## 22.0 REQUIREMENTS RESULTING FROM FUKUSHIMA NEAR-TERM TASK FORCE RECOMMENDATIONS

This FSAR chapter addresses the requirements resulting from the Fukushima Near-Term Task Force (NTTF) recommendations that are applicable to the South Texas Project (STP) Units 3 and 4 Combined License (COL) application. The applicable recommendations address four topics: a reevaluation of the seismic hazard (related to Recommendation 2.1), mitigation strategies for beyond-design-basis external events (related to Recommendation 4.2), spent fuel pool (SFP) instrumentation (related to Recommendation 7.1), and emergency preparedness staffing and communications (related to Recommendation 9.3).

## **22.1 Recommendation 2.1 Seismic Hazard Reevaluation**

**Figure 22.1-6 Comparison of the Horizontal STP Units 3 and 4 Site-Specific SSE—the STP Units 3 and 4 COL Application GMRS—and the Houston Test Site CEUSSSC GMRS**

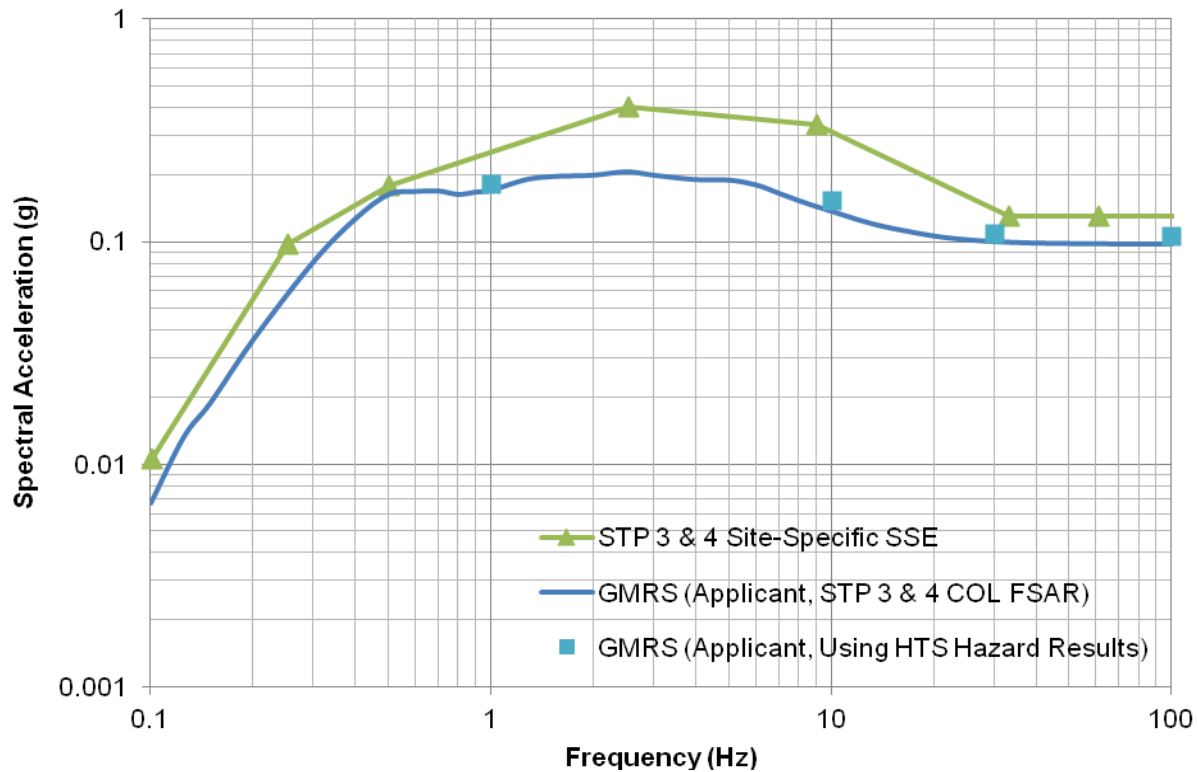
Using the procedure recommended in RG 1.208, the applicant then developed a hard rock GMRS at frequencies of 1, 10, 30, and 100 Hz. Next, the applicant scaled the hard rock GMRS by the STP site-specific amplification factors (i.e., from FSAR Table 2.5S.2-21) at the corresponding frequencies. The applicant's GMRS values are in Figure 22.1-6 of this SER, in addition to the STP COL application GMRS and the STP site-specific safe-shutdown earthquake (SSE) ground motion. Based on this comparison, the applicant concluded that the estimated CEUS-SSC STP GMRS is very close to—and not significantly above—the STP COL application GMRS, while the site-specific SSE envelopes the GMRS from both. The applicant further concluded that because the STP Units 3 and 4 COL application GMRS and the estimated CEUS-SSC results for the STP site are not significantly different, the STP Units 3 and 4 COL seismic design basis does not need to be revised.

**Figure 22.1-7 Plot Comparing the Staff's 1-Hz Total Mean Hazard Curves for the Distributed Seismicity Source Zones for the STP Site and the Houston Test Site (HTS). (Also Shown Is the NUREG-2115 1-Hz Total Mean Hazard Curve for the Distributed Seismicity Source Zones for the Houston Test Site)**

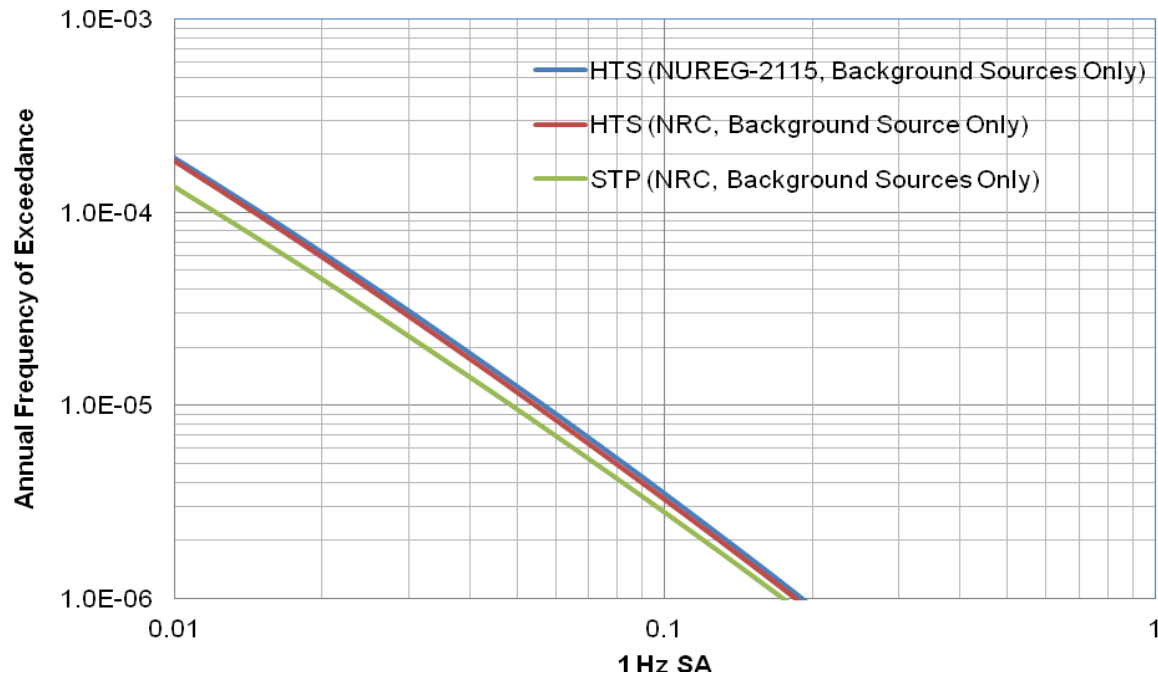
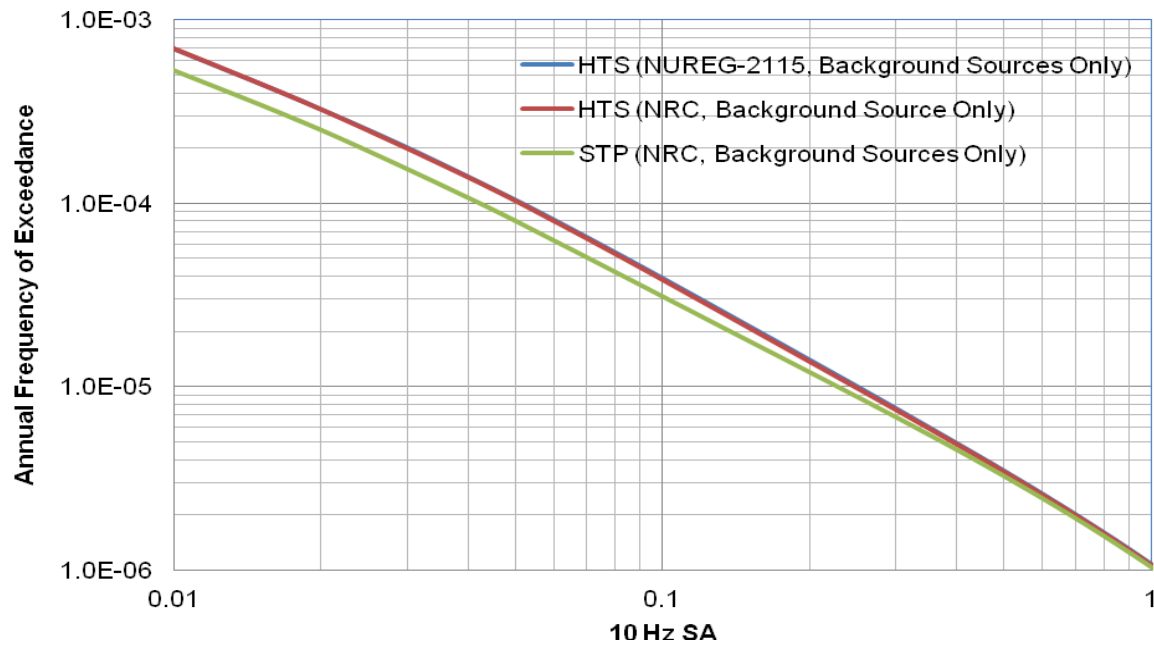
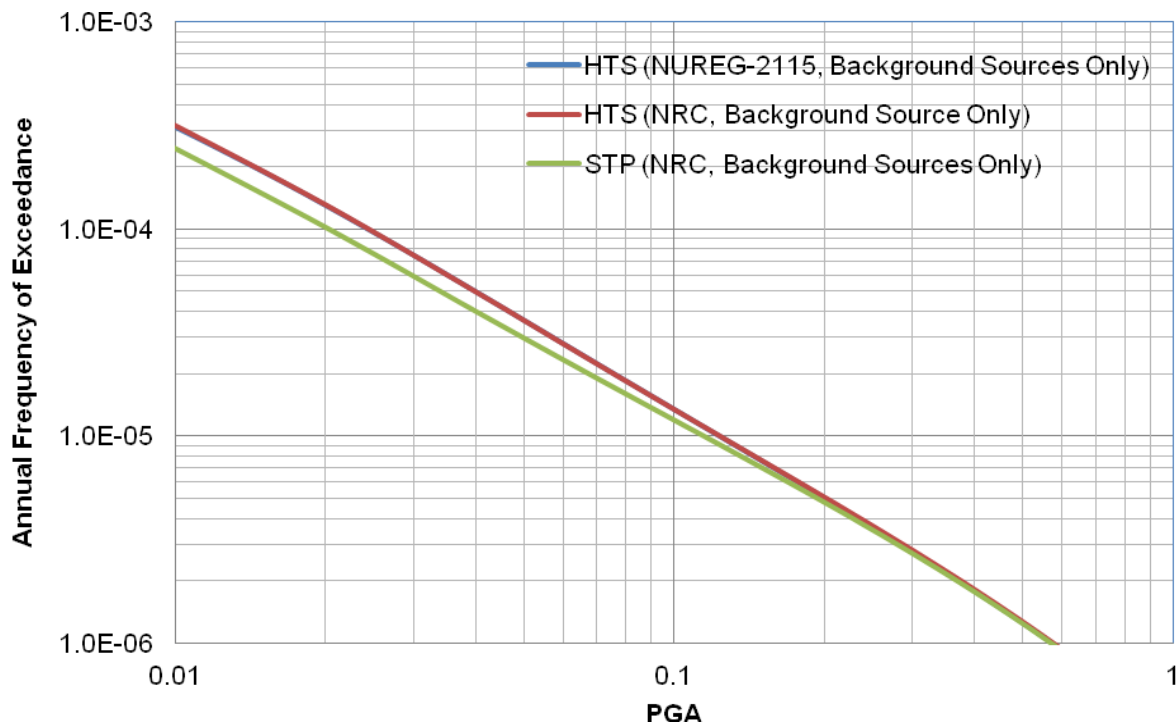
In order to confirm the applicant's assumption that the Houston Test Site hazard curves are appropriate for estimating reference rock seismic hazard curves at the STP site, the staff performed a confirmatory PSHA for the STP site and the Houston Test Site and compared the results with those in NUREG-2115 for the Houston Test Site. The staff used the CEUS-SSC model (NUREG-2115) with the EPRI (2004, 2006) GMM. The staff used the NUREG-2115 Houston Test Site distributed seismicity sources in this confirmatory PSHA. The staff compared the confirmatory 1-, 10-, and 100-Hz hazard curve results for both the STP site and the Houston Test Site with the Houston Test Site results in the NUREG-2115 report for the distributed seismicity sources. The staff determined that the two sets of results are almost identical. This comparison is illustrated in Figures 22.1-7 through 22.1-9 of this SER. The figures show the PSHA hard rock seismic hazard curve results for 1, 10, and 100 Hz, respectively, for the distributed seismicity sources. These figures also show a comparison of the staff's results for the STP site and the Houston Test Site, which indicates that the STP hazard curves are close to or less than the Houston Test Site hazard curves at frequencies of 1, 10, and 100 Hz.

Based on the above assessment, the staff concludes that the COL applicant's use of the NUREG-2115 hazard curves for the Houston Test Site at 1 Hz, 10 Hz, and 100 Hz is an adequate substitute for performing hazard calculations for the STP site using the CEUS-SSC model. Because the RLME sources are quite distant from both the Houston and STP sites, the staff only used the distributed seismicity sources in the confirmatory PSHA analysis. Including

**Figure 22.1-10 Comparisons of the Staff's Site Response Amplification Functions with the COL Applicant's Amplification Functions (Taken from FSAR Figures 2.5S.2-39, 2.5S.2-41, 2.5S.2-43, and 2.5S.2-45)**

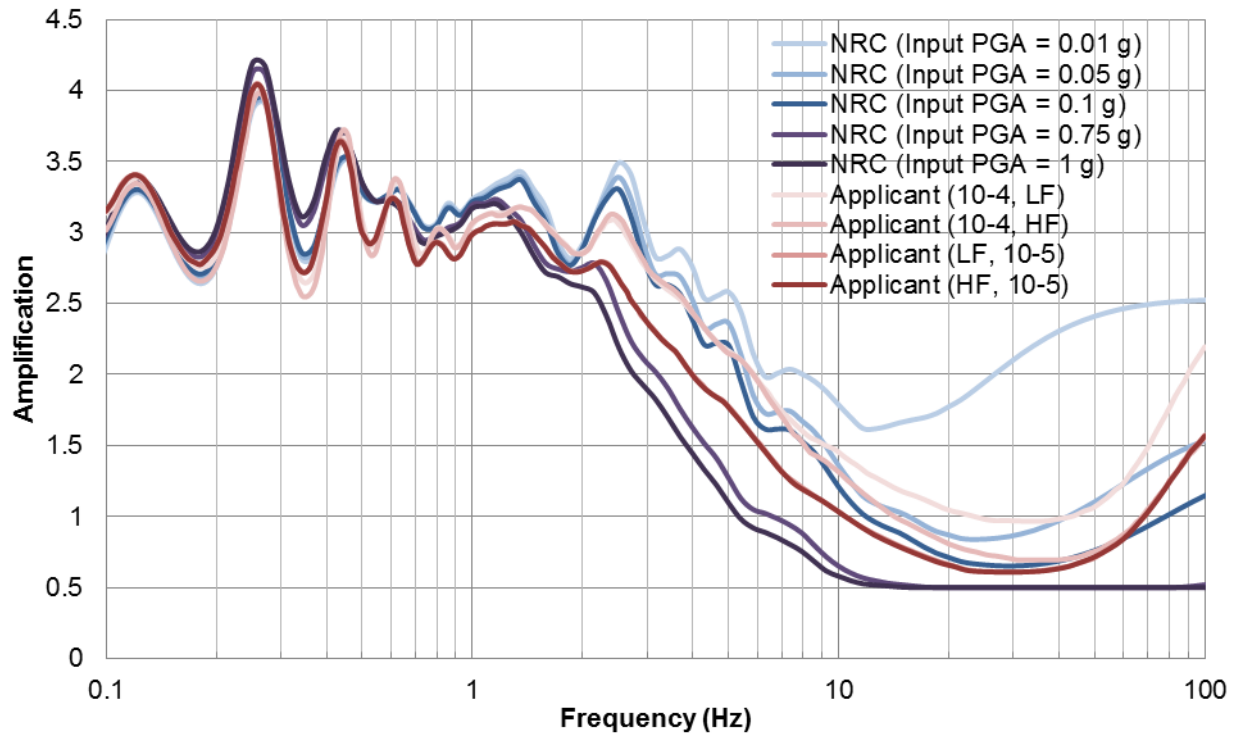
The staff also performed confirmatory site response calculations to determine the adequacy of the applicant's GMRS. For these calculations, the staff used the information on static and dynamic soil properties in COL FSAR Subsection 2.5S.2.5. The staff used 7 spectral frequencies and 11 input rock amplitudes. Figure 22.1-10 of this SER shows a comparison of the staff's mean site amplification function results with the COL applicant's results.

As shown in Figure 22.1-10, the COL applicant's and the staff's results are similar. The staff then used the amplification functions and the CEUS-SSC hard rock hazard curves for the Houston Test Site to develop probabilistic soil hazard curves that adhere to the methodology described in EPRI Technical Report 102587, "Seismic Evaluation Guidance," (EPRI, 2012) and NUREG/CR-6728, "Technical Basis for Revision of Regulatory Guidance on Design Ground Motions: Hazard- and Risk-Consistent Ground Motion Spectra Guidelines," (McGuire, et al., 2001). The staff then developed a GMRS at seven spectral frequencies using an approach that is consistent with RG 1.208. The staff's GMRS is depicted in Figure 22.1-11 of this SER.

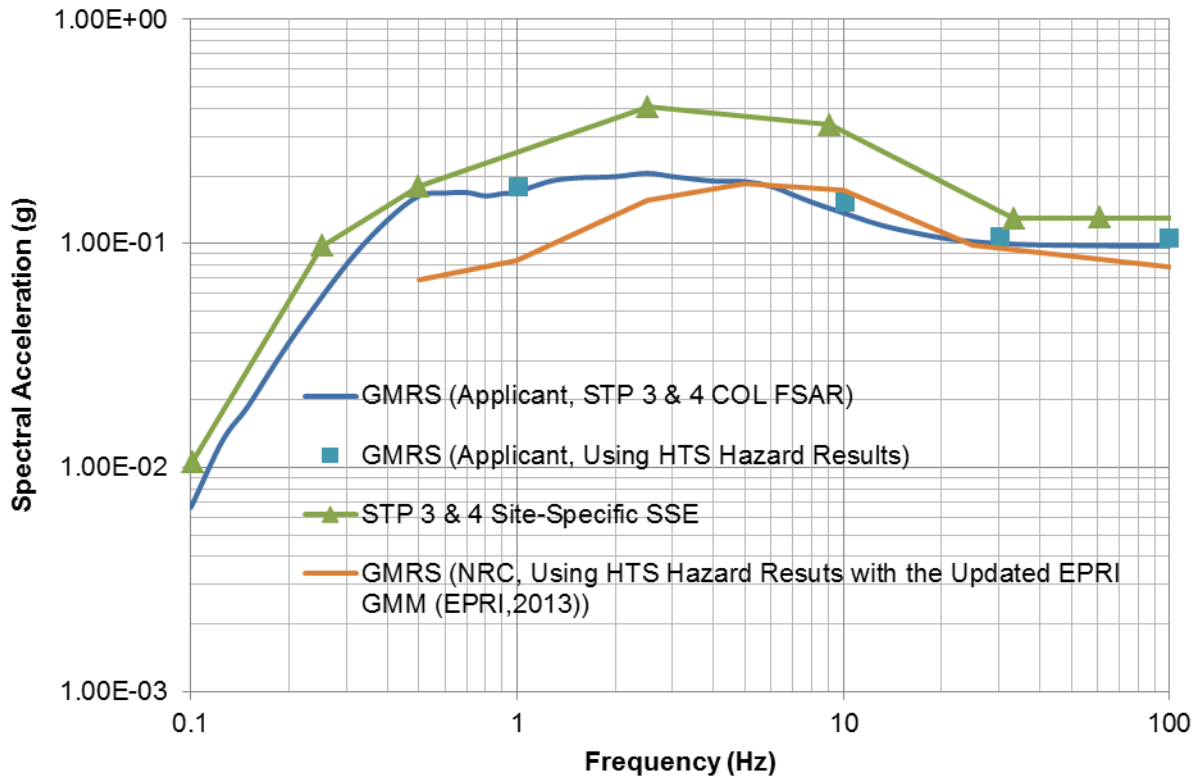
In a letter dated August 28, 2013 (ML13233A102), the NRC stated that the updated GMM is an acceptable model for use by CEUS plants in developing a plant-specific GMRS. The staff calculated the STP GMRS using the CEUS-SSC Houston Test Site hazard results with the Updated EPRI (2004, 2006) GMM (EPRI, 2013). This GMRS is plotted in Figure 22.1-11 of this SER (the light brown curve) and is lower than the STP Units 3 and 4 COL application site-specific GMRS (dark blue curve) for the entire 0.5- to 100-Hz frequency range with the exception of 10 Hz. Although the STP Units 3 and 4 GMRS is exceeded by the staff's CEUS-SSC GMRS at 10 Hz by ~20 percent, the CEUS-SSC GMRS developed by the staff falls well below the STP Units 3 and 4 site-specific SSE. The staff notes that it used a different site response method to develop the CEUS-SSC GMRS than the COL applicant used to develop the STP Units 3 and 4 GMRS. The COL applicant used Approach 2 while the staff used Approach 3, which are described in NUREG/CR-6728. Using either Approach 2 or Approach 3 is consistent with the guidance provided in RG 1.208. Unlike Approach 3, however, Approach 2 does not explicitly incorporate the amplification function uncertainty into the development of the soil UHRS and subsequent GMRS. In a sensitivity calculation, the staff determined that neglecting the amplification function uncertainty resulted in a reduced GMRS across the entire frequency range and at 10 Hz, the STP Units 3 and 4 GMRS is exceeded by the staff's CEUS-SSC GMRS by ~10 percent. In sum, the applicant's GMRS, which is set forth in FSAR Section 2.5S.2.6, and the staff-calculated GRMS are within the limits of uncertainty, and both sets of results are bounded by the site-specific SSE. Based on the above comparison, the staff accepts the applicant's decision not to update the STP Units 3 and 4 COL application site-specific GMRS and its site-specific SSE.

3. The staff's site-specific GMRS, which is based on the CEUS-SSC model used for the Houston Test Site and the Updated EPRI (2004, 2006) GMM, is well below the STP Units 3 and 4 COL FSAR GMRS calculated by the applicant using the updated EPRI-SOG model for the entire 0.5- to 100-Hz frequency range with the exception of 10 Hz. The staff concludes that the ~20 percent exceedance of the STP Units 3 and 4 GMRS by the staff's

CEUS-SSC GMRS at 10 Hz is within the limits of uncertainties. Therefore, no revisions to the STP Units 3 and 4 COL FSAR GMRS are necessary.
